OAKLEY STREET HOUSING SUPPORT CENTER

RFB-DCB-01-26

ADDENDUM # 2

Re: Questions and Answers; updated technical specifications; updated drawings

FIRE PROTECTION: SYMBOLS, NOTES & ABBREVIATIONS

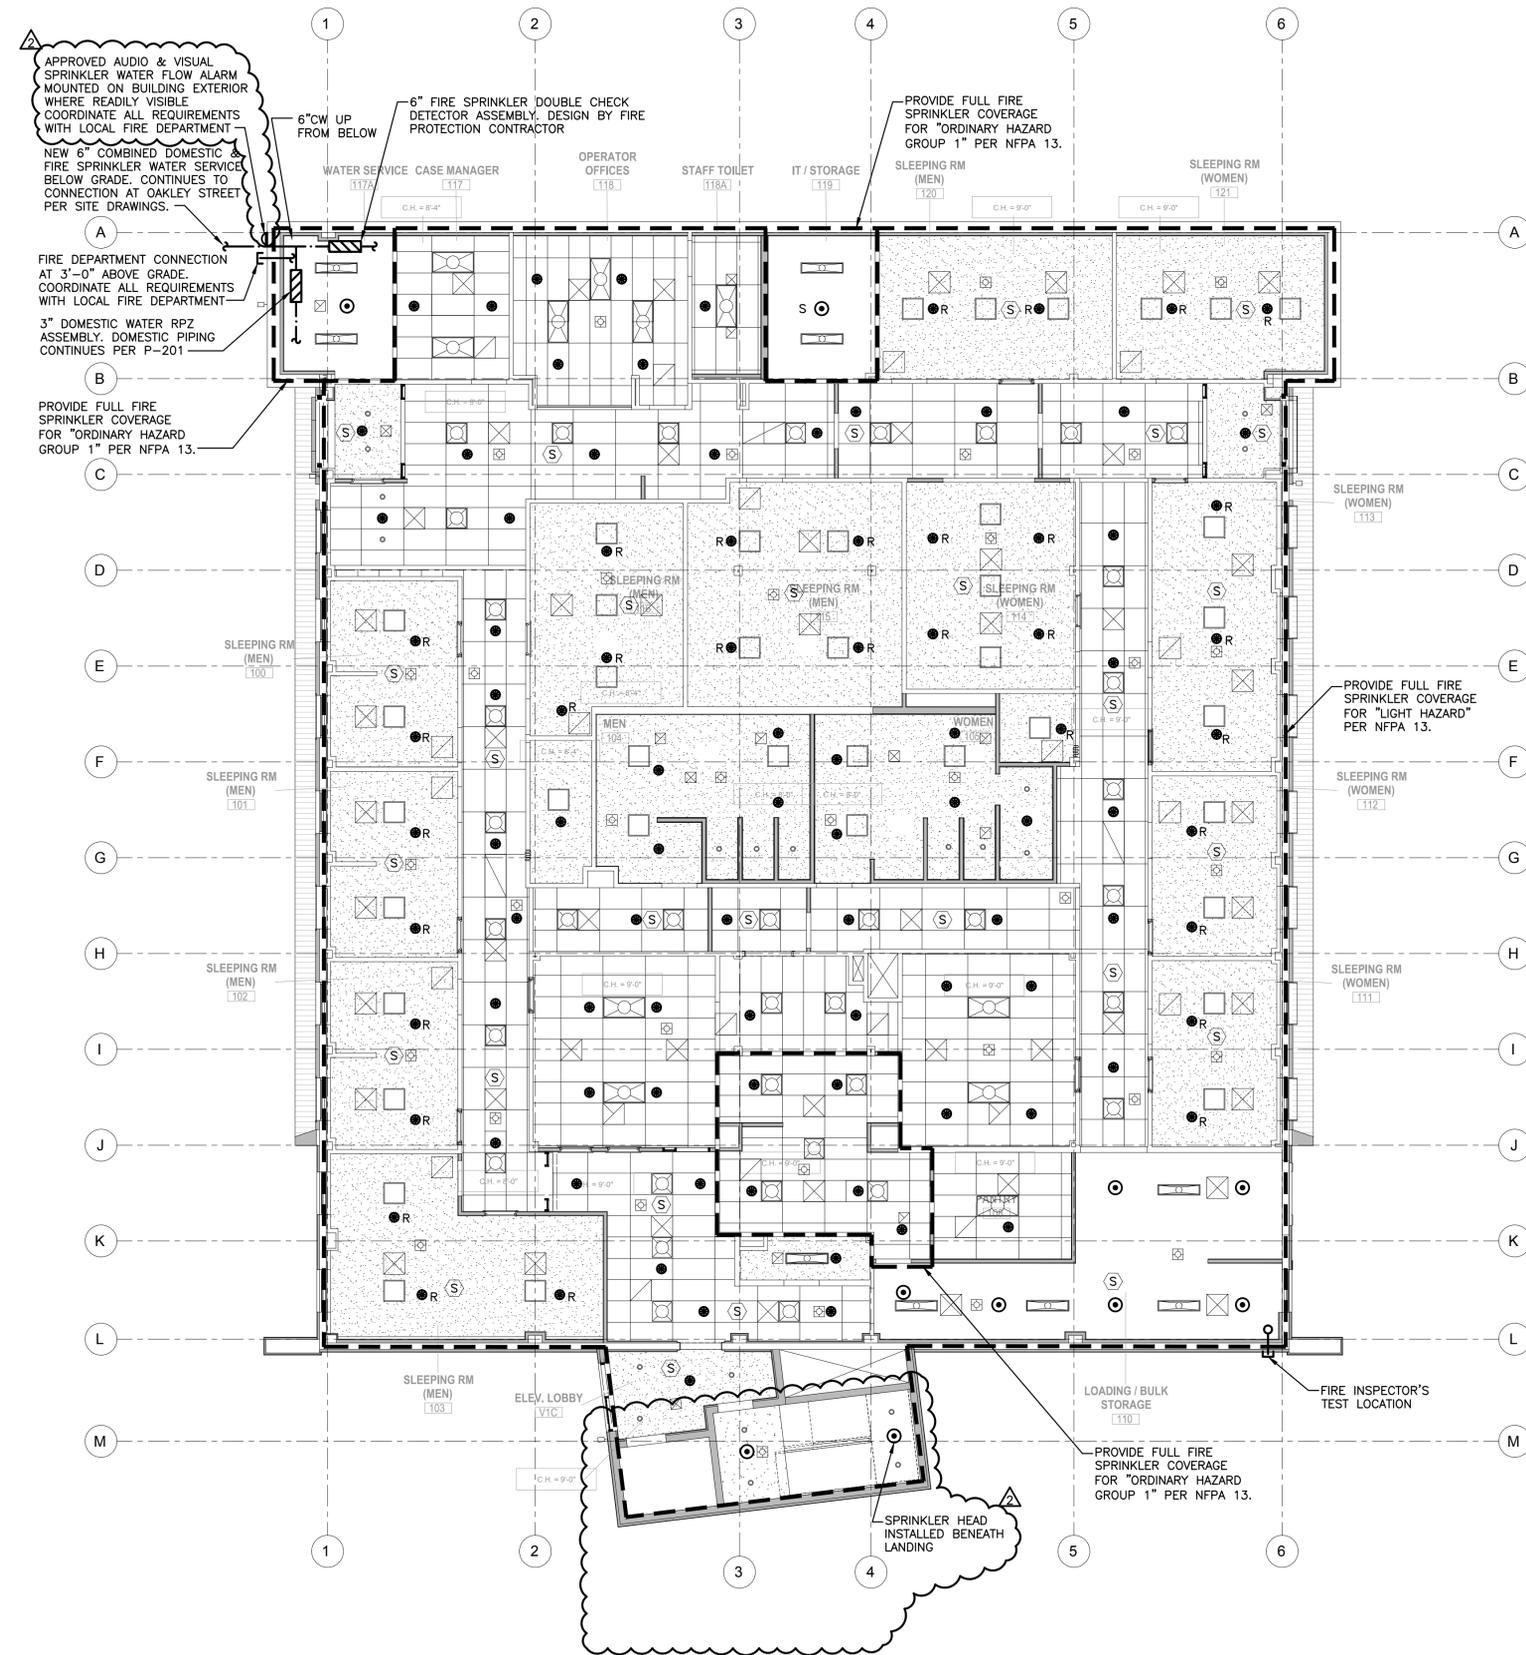
5. SHEET FP-001 (SEE REVISED DRAWING):

- FIRE PROTECTION SYSTEM NOTES 6 & 11 HAVE BEEN MODIFIED.
- DETAIL #5, ADD AUDIO/VISUAL ALARM ON BUILDING EXTERIOR.

1 ELECTRICAL: 1ST FLOOR CONSTRUCTION POWER PLAN
SCALE: 1/8"=1'-0"

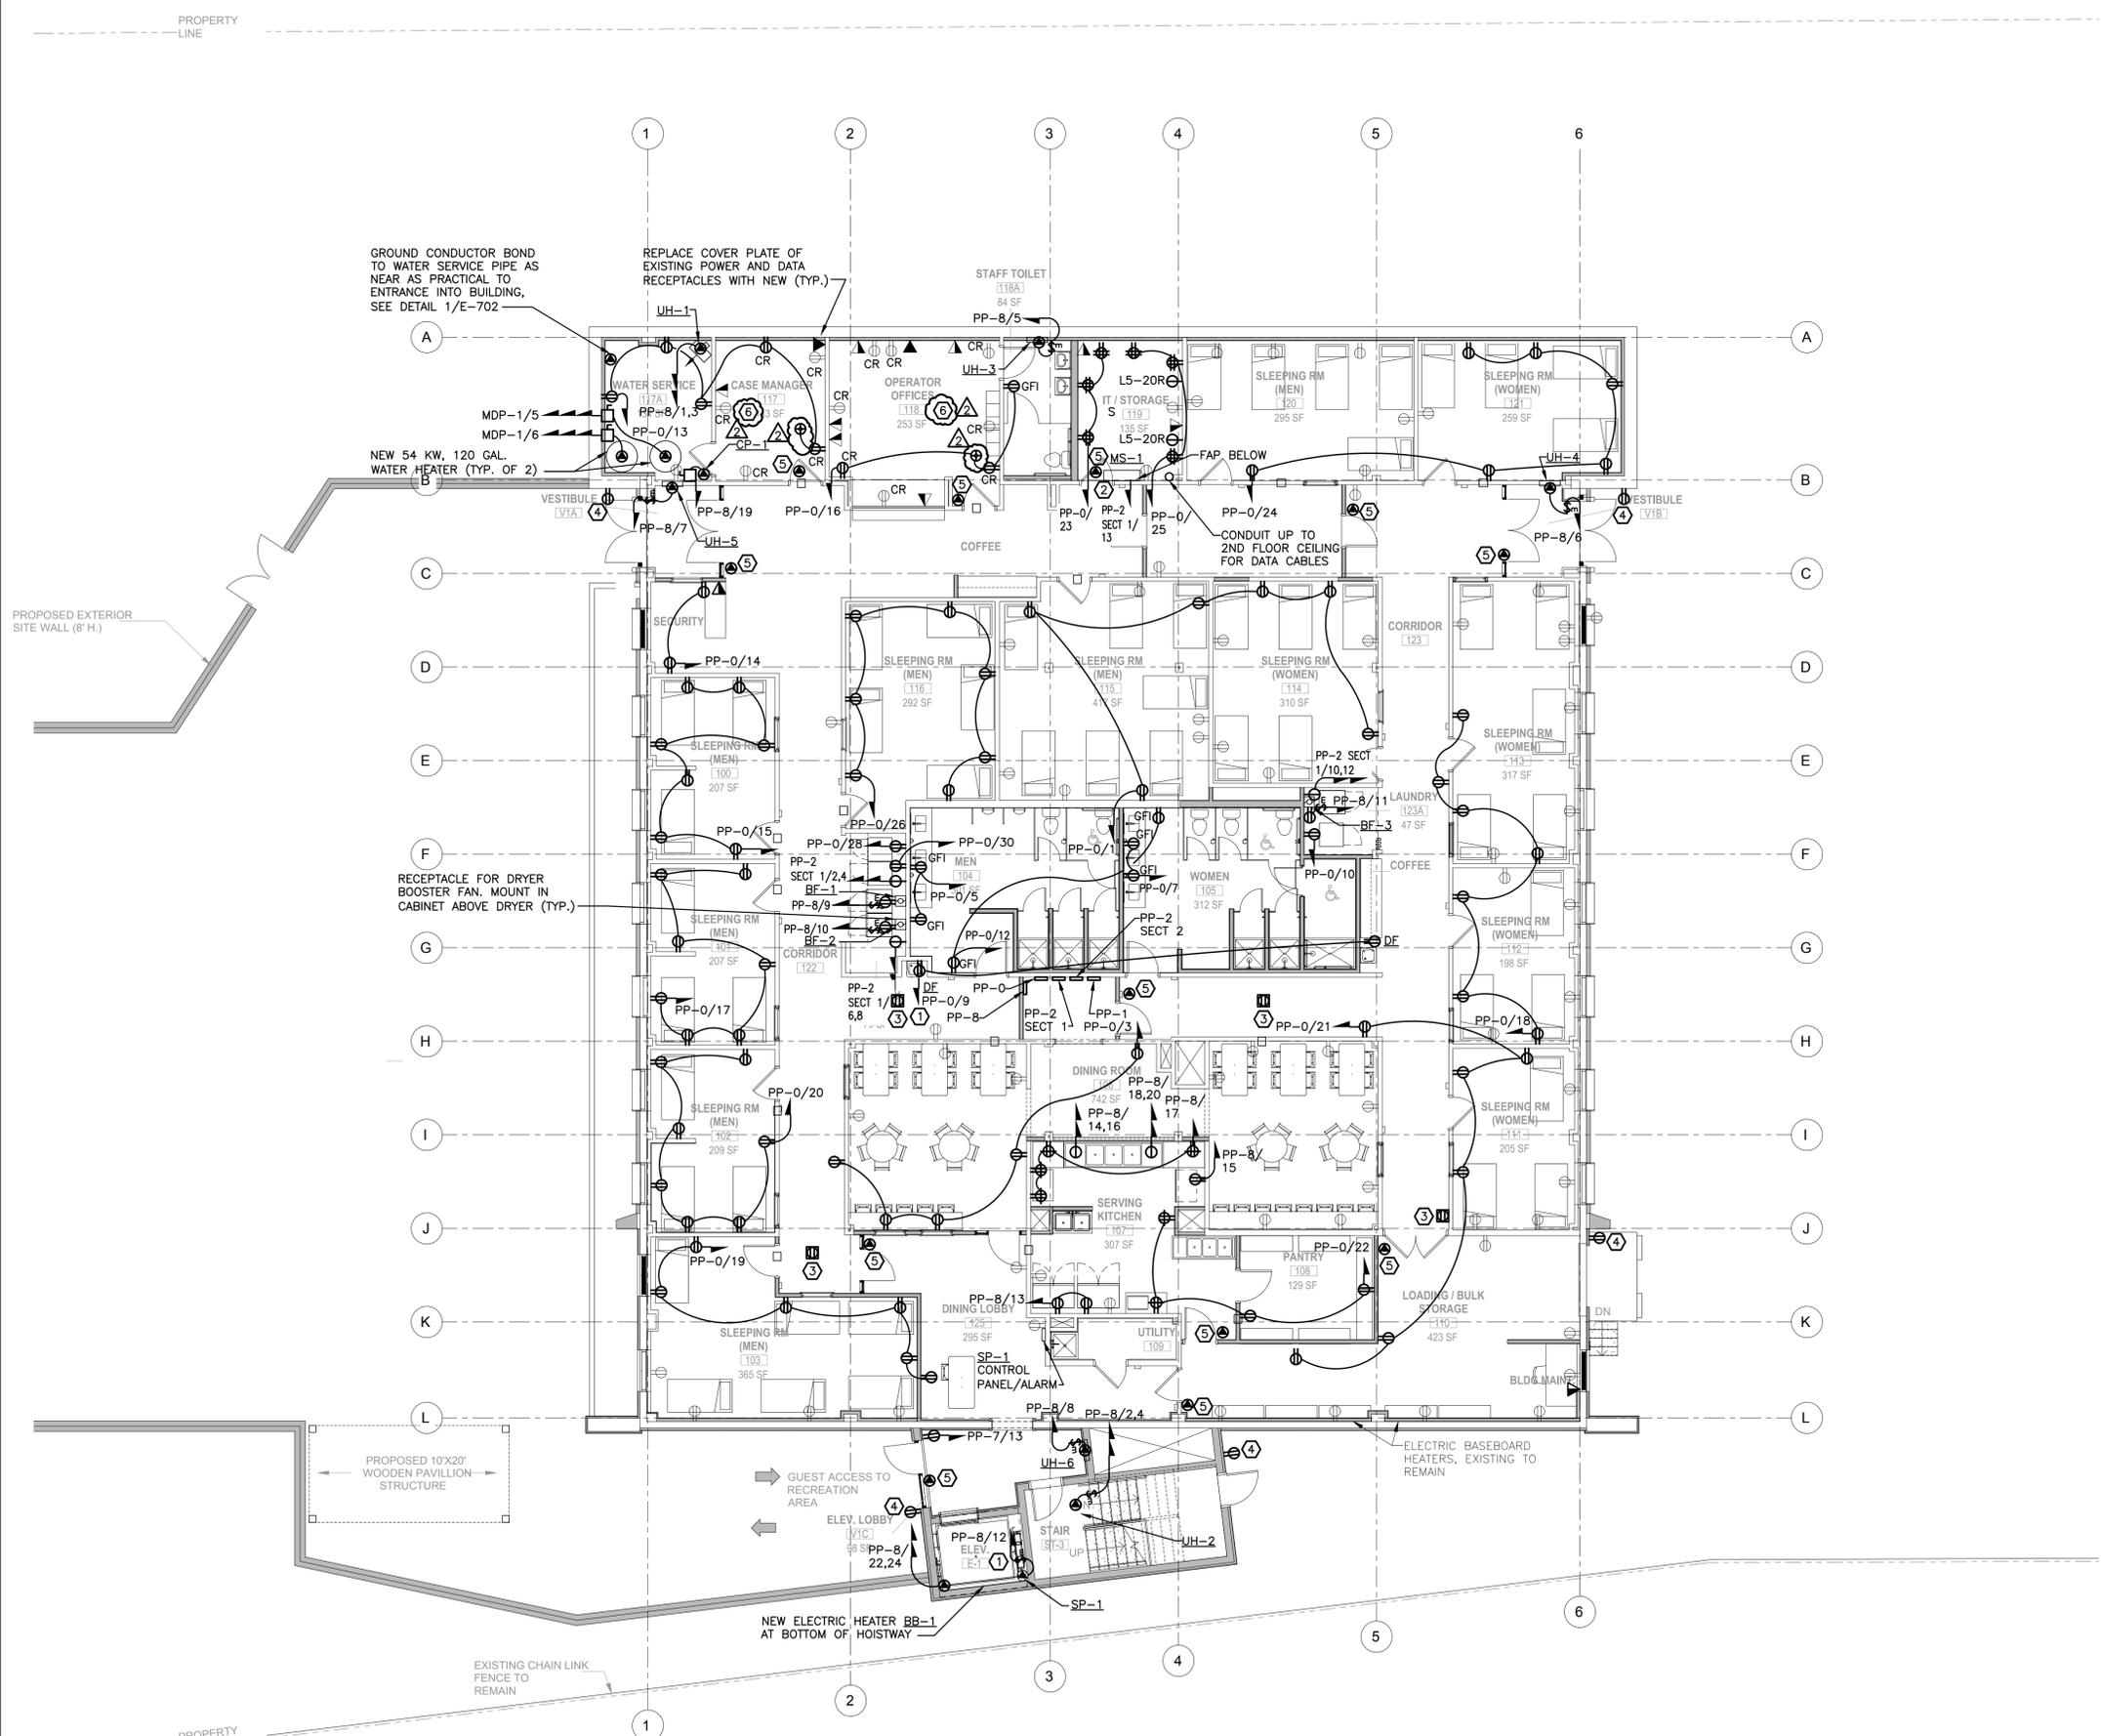
11. SHEET E-101:
- ADD CONTROLLED RECEPTACLES AND CEILING MOUNTED OCCUPANCY SENSOR TO OFFICES.
 - ADD KEYED NOTE 6 REGARDING CONTROLLED RECEPTACLES.
12. SHEET E-102:

ELECTRICAL:
2ND FLOOR
CONSTRUCTION
POWER PLAN

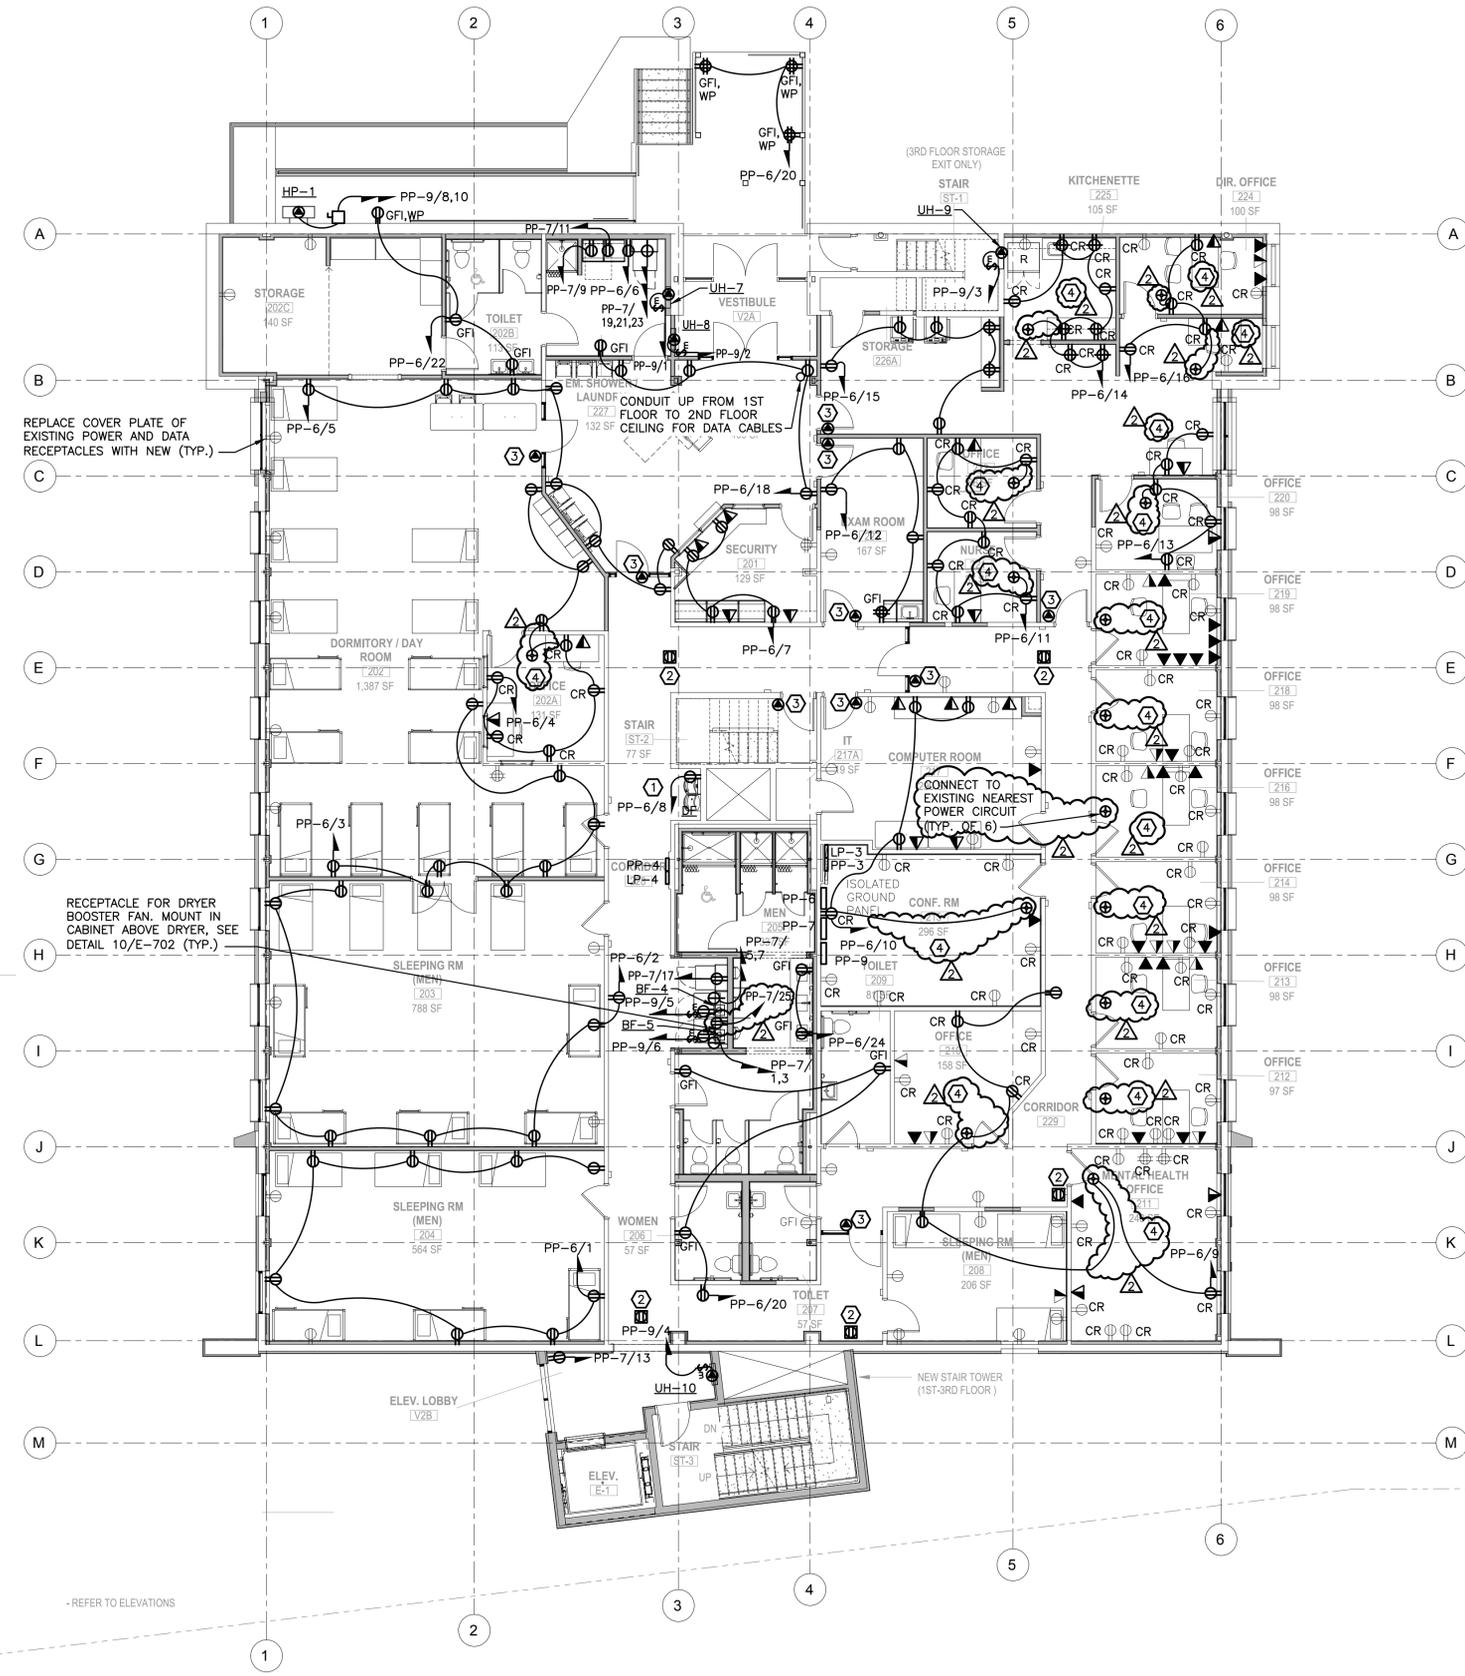
- ADD CONTROLLED RECEPTACLES AND CEILING MOUNTED OCCUPANCY SENSOR TO OFFICES/CONFERENCE ROOMS.
 - ADD KEYED NOTE 4 REGARDING CONTROLLED RECEPTACLES.

2 ELECTRICAL: IT/STORAGE ROOM EXTENDED VIEW PLAN
SCALE: 1/2"=1'-0"

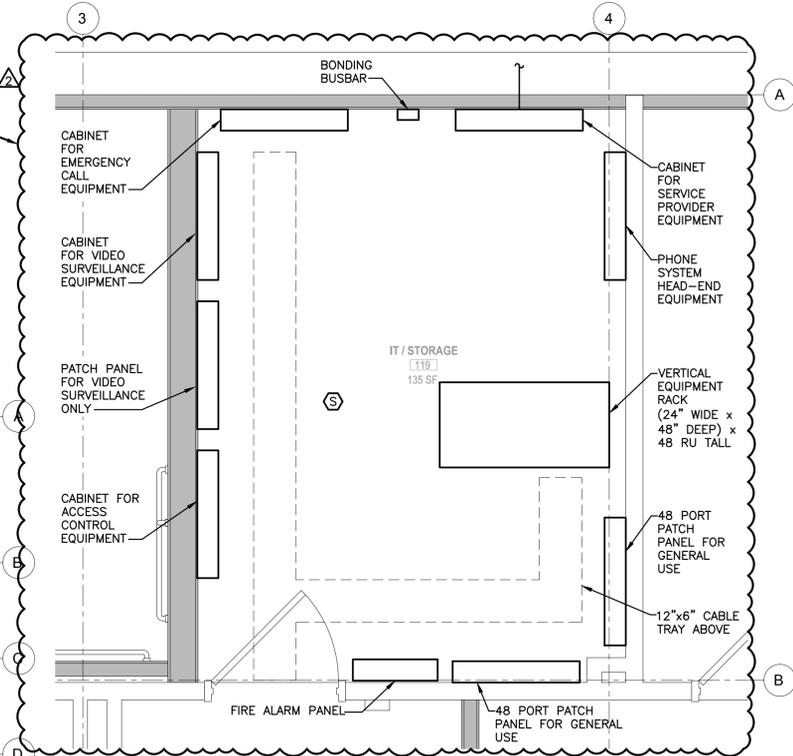
15. SHEET E-301:

- MAKE CAMERA LOCATIONS VISIBLE ON SHEET.
- MAKE IT/STORAGE ROOM EQUIPMENT OUTLINES VISIBLE ON SHEET.
- ADD OUTDOOR-RATED HORN-STROBE TO OUTSIDE VESTIBLE V1A.
- ADD HORN-STROBE IN CORRIDOR 122.
- RELOCATE PULL STATION FROM INSIDE STAIR TOWER TO DINING LOBBY PRIOR TO ENTERING STAIR TOWER.
- DELETE STROBE FROM STAIRWELL ST-3.
- DELETE DOORHOLDS FROM RESTROOM CORRIDOR WHERE NO DOORS ARE LOCATED.
